# SERVICE BULLETIN

## CHECKING AND REPLACEMENT OF STATOR ASSY.

SB-912 026 /E

SB-914 014 /E

Bild / Fig. 1

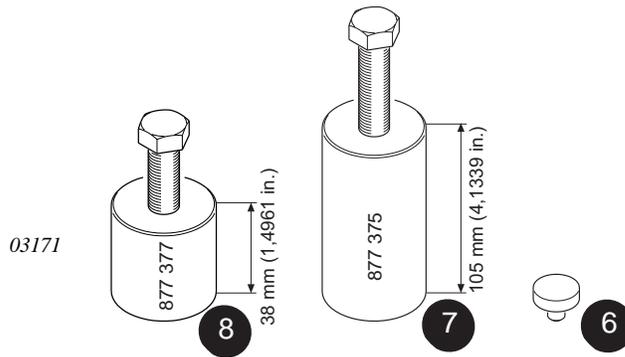
See fig. 1 und 5.

- Remove hex. screw M16x1,5 x 40 (16) together with washer (17) and shim (18).
- Apply some grease on protection piece (part no. 877.410) and place it onto the crankshaft, screw puller (part no. 877.375)(7) or screw puller (part no. 877.377) (8) fully home on thread (19) and pull off flywheel assy. (20).
- Lay flywheel assy. aside so that no particles can collect on the magnets.

Bild / Fig. 2

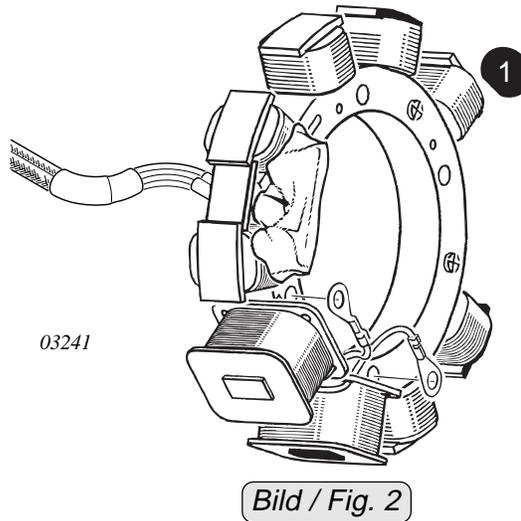
See fig. 2 and 5.

- Check all cable connectors, all ground connections, charging and shorting cables and grounding cables for tight fit, good contact, corrosion and security, repair as required.
- Verify shielding of cable assemblies for damage, for ground contact and security.
- Inspect all 8 ignition cables to spark plug connector for damage and tight fit. Check resistor plug connector for tight fit on spark plug. Repair or replace as necessary.

Bild / Fig. 3

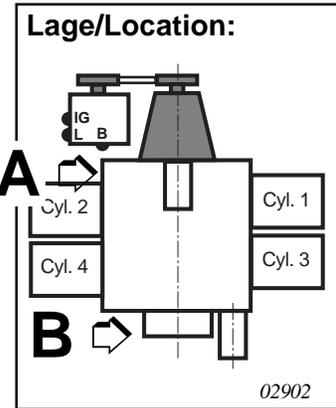
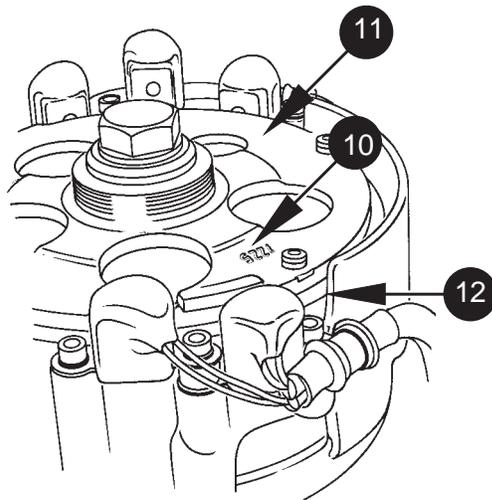
See fig. 3 and 4.

- To lock the crankshaft remove the plug screw (1) M8x20 and sealing ring from the crankcase half (cyl. 2/4) (9). Turn crankshaft until the pistons of cyl. no. 1 and no. 2 are in T.D.C. and lock crankshaft in this position with the crankshaft locking screw (5) (part no. 240.880).

- For easy location finding of the correct crankshaft position, turn crankshaft so that the impressed 4-digit number (10) on the flywheel hub (11) aligns with the edge (12) of the ignition housing.
- The required crankshaft recess position (13) can be additionally verified with a flashlight through the hole in the crankcase (9).
- Turn-in crankshaft locking screw and rotate crankshaft slightly to-and-fro until the screw engages noticeably in the recess (13) of the crankshaft and tighten locking screw to 10 Nm (90 in.lb).

Bild / Fig. 5

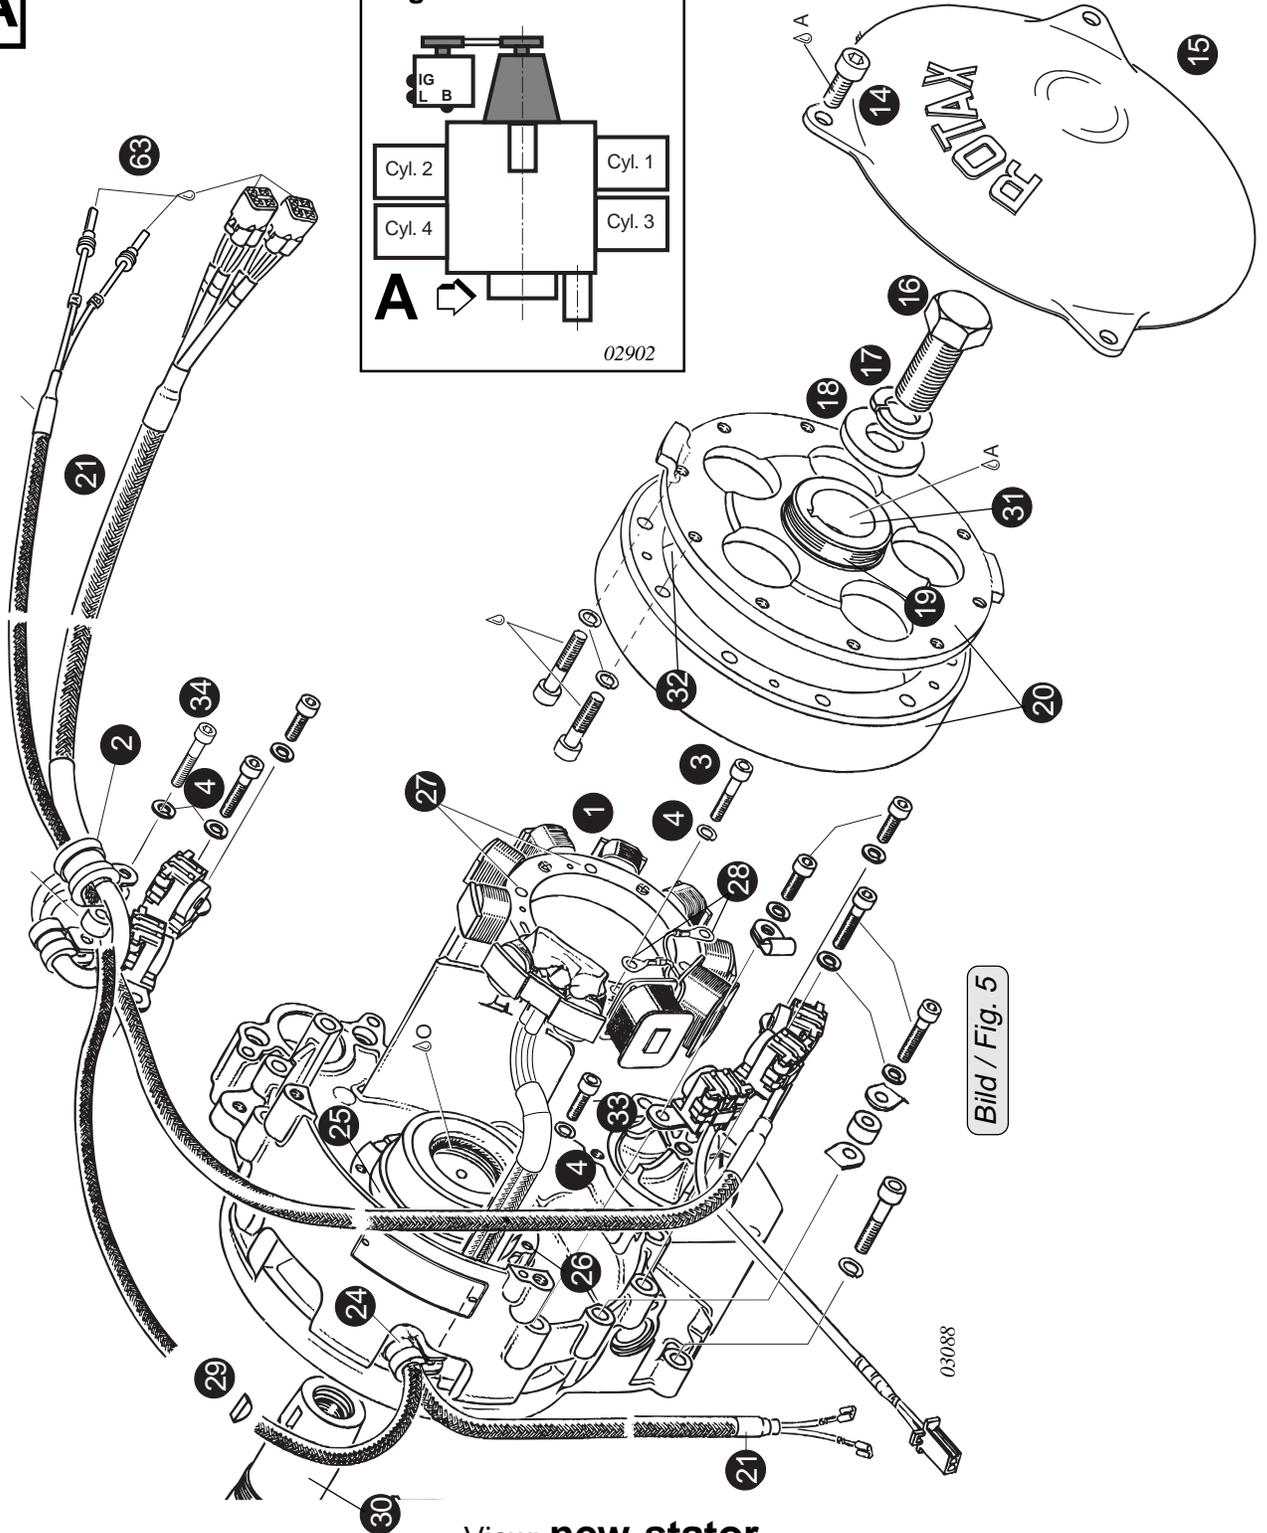
## 3.2.4) Removal of stator assy.

See fig. 5, 8, 9 and 11.

- Remove the 4 Allen screws M5x25 (3) along with lock washer.
- **Group A/B and E:** To detach the cable harness (21) remove the Allen screw (33) M5x16 and Allen screw (34) M5x30 along with lock washer. Remove the cable clamp (part no. 851.110) (24) and cable clamp (part no. 851.250) (2). Mark the plug connections (63) for convenience at reassembly, disconnect plug and detach plastic clamps (62) and cable clamp (64).

- **Group C and D:** To detach the cable harness (21) and grounding cable (72) remove the Allen screw (22) M5x20 and Allen screw (35) M6x30 along with lock washer. Remove both cable clamps (part no. 851.110) (24). Open the screening box (49) and mark the plug (50) of charging cable for convenience at reassembly and disconnect the plug. Detach clip plate and remove the cable harness from the clip plate (51).

- Remove the stator ass'y (1) from the centering (25) of the ignition housing.

## 3.2.6) Installation of the new stator assy.

See fig. 5, 8, 9 and 11.

- The contact faces **(26)** between stator and ignition housing must be clean to assure good ground connection.
- At replacement or re-installation of the stator take care for correct routing of cable assembly and not to damage the stator.

- **ATTENTION:** Make sure not to squeeze the cable harness.
- At installation apply Lithium grease to the contact faces **(27)** of the stator and the screw heads.

- Install stator ass'y on the centering of ignition housing. Fit the 4 Allen screws **(3)** M5x25 and tighten to 6 Nm (53 in.lb).
- **ATTENTION:** One each charging coil grounding cable **(28)** has to be connected with stator attachment screw.

- **Group A/B and E:** To install the cable harness **(21)** fit the cable clamp (part no. 851.250) **(24)** with Allen screw **(33)** M5x16 and cable clamp (part no. 851.250) **(2)** with Allen screw **(34)** M5x30 and lock washer. Attach cable harness with cable clamp **(64)**. Re-establish plug connection corresponding with marking. Secure with plastic clamps.

- **Group C and D:** Attach grounding cables **(72)** with Allen screw **(35)** M6x30 and lock washer. To attach the cable harness **(21)** use the cable clamp (part no. 851.250) **(24)** and Allen screw **(33)**. Fit cable harness on clip plate **(51)** and attach. Reconnect plug **(50)** corresponding to marking. Close the screening box **(49)**, secure cables with new plastic clamps.

*Bild / Fig. 6*

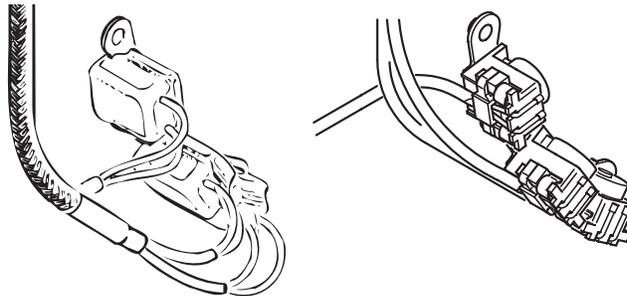
See fig. 5, 6, 7 and 10.

- Inspect magneto inner side (32) for any foreign particles and the taper surface (31). Under normal circumstances it is not necessary to take the flywheel apart.
  - Check Woodruff key (29) in crankshaft for tight fit and degrease taper of crankshaft (30) and flywheel hub (31). Apply LOCTITE 221 sparingly, but well spread into the taper of magneto hub.
  - Fit flywheel hub ass'y, washer 17/36/5 (18), lock washer (17) and hex. screw M16x1,5 x 40 (16) and tighten to 120 Nm (1060 in.lb).
- ▲ **WARNING:** Make sure that the Woodruff key remains in the keyway.

- Remove crankshaft locking screw (part no. 240 880)
- Install the plug screw M8x20 and shim on crankcase half (2/4). Tightening torque 22 Nm (195 in.lb.).
- Check or adjust the air gap of the external triggers with feeler gauge to dimension ①.

Maße/Dimensions	Neu/New	Verschleißgrenze/Wear limit
Geberspalt für "alte" Geber gap for "old type" trigger coil	0,4 ÷ 0,5 mm (0,016 ÷ 0,020 in.)	0,5 mm (0,020 in.)
Geberspalt für Geber mit Klammern gap for trigger coil with clamps	0,3 ÷ 0,4 mm (0,012 , 0,016 in.)	0,4 mm (0,016 in.)
